Errata Sheet

June 18, 2001 / Release 1.2

Device:	SAK-C167CR-L(33)M, SAF-C167CR-L(33)M, SAB-C167CR-L(33)M SAK-C167CR-4R(33)M, SAF-C167CR-4R(33)M, SAB-C167CR-4R(33)M SAK-C167CR-16R(33)M, SAF-C167CR-16R(33)M, SAB-C167CR-16R(33)M SAK-C167SR-L(33)M
Stepping Code / Marking:	ES-GA, GA, GA-T, GA-T 6 ES-JA
Package:	P-MQFP-144-1, P-MQFP-144-6 (GA-T 6)

Timing of flag SSCTIR (SSC Transmit Interrupt Request)

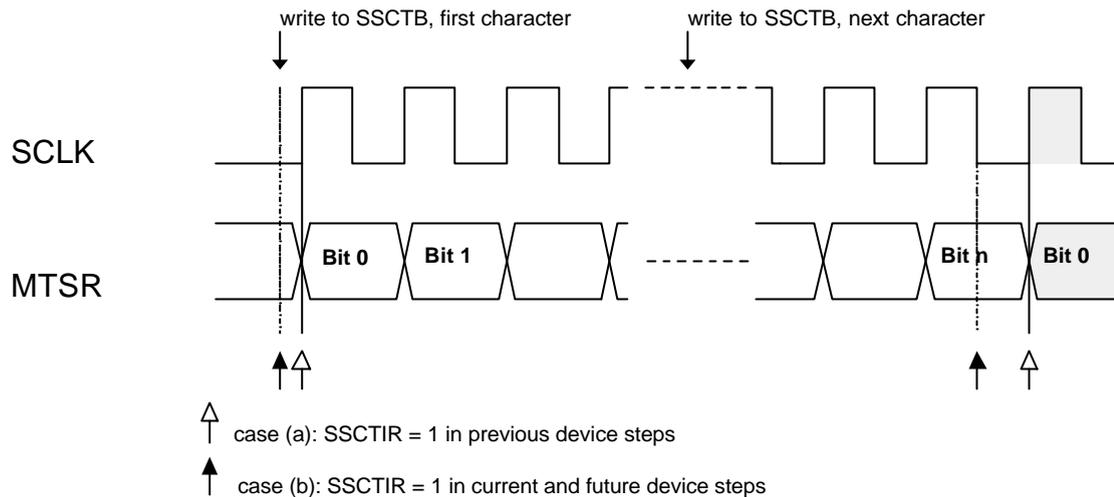
In master mode, the timing of SSCTIR depends on the device step as follows:

- before step **FA**, flag SSCTIR is set to '1' synchronous to the shift clock SCLK 1/2 bit time before the first latching edge (= first shifting clock edge when SSCPH = 0). When SSCTB is written while the shift register is empty, the maximum delay between the time SSCTB has been written and flag SSCTIR=1 is up to 1/2 bit time.
- beginning with step **FA**, when SSCTB has been written while the transmit shift register was empty (and the SSC is enabled), flag SSCTIR is set to '1' directly after completion of the write operation, independent of the selected baud rate. When the transmit shift register is not empty when SSCTB was written, SSCTIR is set to '1' after the last latching edge of SCLK (= 1/2 bit time before the first shifting edge of the next character). See also e.g. C167CR User's Manual V3.1, p. 12-5.

The following diagram shows these relations in an example for a data transfer in master mode with SSCPO = 0 and SSCPH = 0. It is assumed that the transmit shift register is empty at the time the first character is written to SSCTB:

Typically, in interrupt driven systems, no problems are expected from the modified timing of flag SSCTIR. However, when flag SSCTIR is polled by software in combination with other flags which are set/cleared at the end or at the beginning of a transfer (e.g. SSCBSY), the modified timing may have an effect.

Another situation where a different system behaviour may be noticed is the case when only one character is transferred by the PEC into the transmit buffer register SSCTB. In this case, 2 interrupt requests from SSCTIR are expected: the 'PEC COUNT = 0' interrupt, and the 'SSCTB empty' interrupt.

- in the **FA** (and newer) steps, the second interrupt request ('SSCTB empty') is always **systematically** generated before the first one ('PEC COUNT = 0') has been acknowledged by the CPU, such that effectively only **one interrupt request** is generated for two different events.

- before step **FA**, when the PEC transfer is performed with sufficient margin to the next clock tick from the SSC baud rate generator, and no higher priority interrupt request has occurred in the meantime, the 'PEC COUNT = 0' interrupt will be acknowledged before the 'SSCTB empty' interrupt request is generated, i.e. **two interrupts** will occur based on these events. However, when the PEC transfer takes place relatively close before the next clock tick from the SSC baud rate generator, or a higher priority interrupt request has occurred while the PEC transfer is performed, the 'PEC COUNT = 0' interrupt may not be acknowledged before the 'SSCTB empty' interrupt request is generated, such that effectively only **one interrupt request** will be generated for two different events.

In order to achieve a defined and systematic behavior with all device steps, the SSC receive interrupt, which is generated at the end of a character transmission, may be used instead of the SSC transmit interrupt.
